DCP/NRC1179
NSD-NRC-97-5484
Docket No.: 52-003

SUBJECT: AP600 RESPONSE TO FSER OPEN ITEMS

**Enclosure to Westinghouse
Letter DCP/NRC1179**

Figure 2 - CMT Level Instrument Details

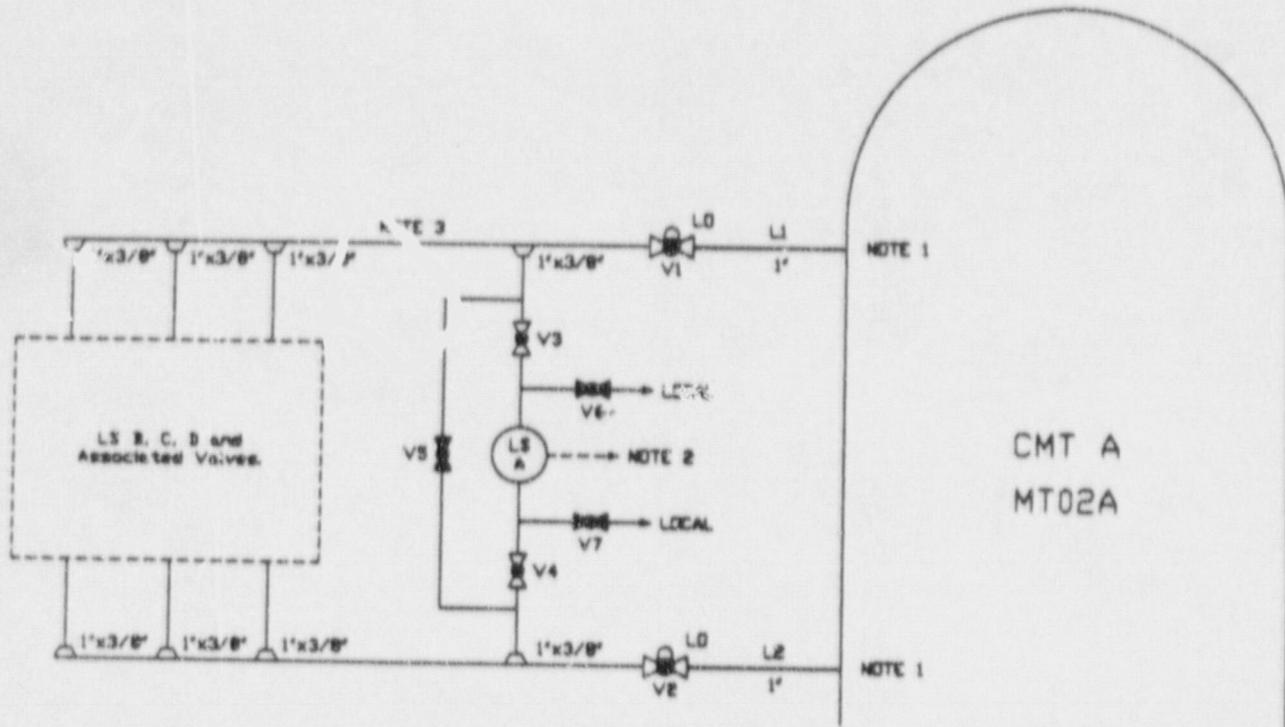
The use of shared level taps is acceptable for the CMT level DP sensors based on the following evaluation. Figure 1 shows CMT and all 10 DP level instruments. Figure 2 shows additional details of one set of the narrow range CMT DP level instruments including their calibration valves. This evaluation includes a failure modes and effects analysis (FMEA) as shown in Table 1. Discussion of this FMEA follows:

8. Breaking of a lower level tap would cause the four DP sensors to read high. This failure would prevent actuation of ADS from the affected CMT. ADS is not required following such a small break because the CVS can makeup for the fluid loss through the 3/8" orifice in the CMT connection. Even if ADS is required the other CMT and its level instruments would provide the actuation signals even with consideration for a single failure.

SSAR Change Add note to SSAR figure 6.3-1.

- NOTES:
1. Provide 3/8" flow restrictor.
 2. CMT level switches have alarm and ADS actuation setpoints.
 3. Locate upper level tap line about 1" below CMT connection.

Figure 40-2

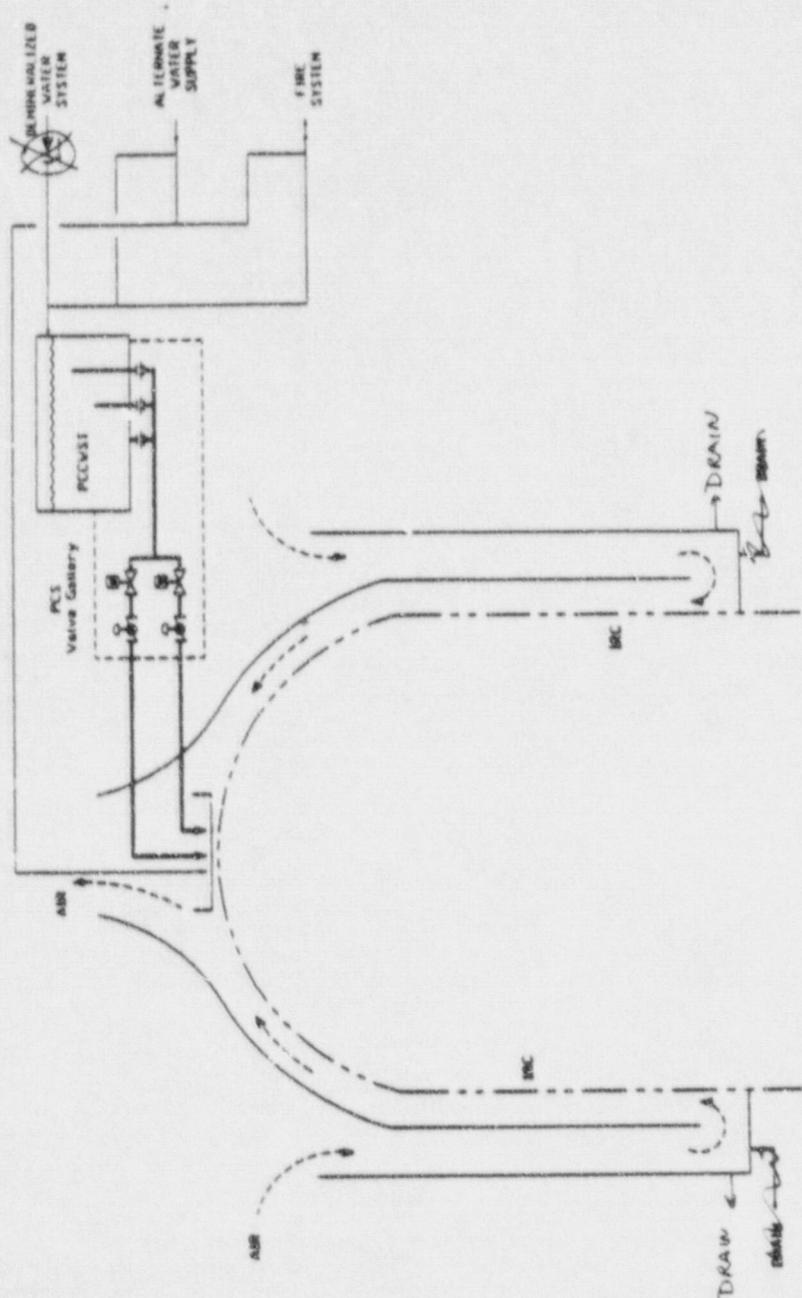
Flooding of the PCS annulus due to plugging of the upper annulus drains is modeled in the AP600 PRA and was assigned a failure probability of 1.0E-04 per demand. In the PRA model, a weekly surveillance interval was considered. The technical specifications, on the other hand, specify surveillance every two years. In addition, the specific drain configuration has changed since the Level 2 PRA was revised in September 1996. As was modeled in the PRA, Revision 8, the drains were located in the floor of the annulus. However, the two 100 percent drain openings are now located in the side wall of the shield building with screens provided to prevent entry of small animals into the drains.

The fact that the surface area of the drains is vertical makes them less susceptible to clogging due to build-up of randomly collected debris, as compared to a configuration with horizontal floor drains. Thus, the drain configuration is more resistant to random plugging than a horizontal floor drain configuration, and would have a smaller failure probability. On the other hand, the technical specification surveillance interval is a factor of 100 above the assumed surveillance used in the PRA model. This change is deemed to have a negative effect compared to the PRA modeling assumption of a weekly surveillance. However, in the PRA failure probability estimate, no attempt was made to tie the estimated failure probability to the surveillance interval. A relatively conservative value of 1.0E-04 per demand was used. There is no systematic drain plugging mechanism envisioned. Thus, the demand failure rate is similar to a "shock failure" mode postulated in common cause failure (CCF) models. There is no need to revise this demand probability due to the revised drain configuration. However, the uncertainty in the failure rate increases due to the increased surveillance interval. The results of sensitivity studies performed to address this uncertainty for the PCS failure probability are summarized below:

Figure 40-2 of PRA Chapter 40, Passive Containment Cooling, will be revised in PRA Revision 11 as shown on the next page.
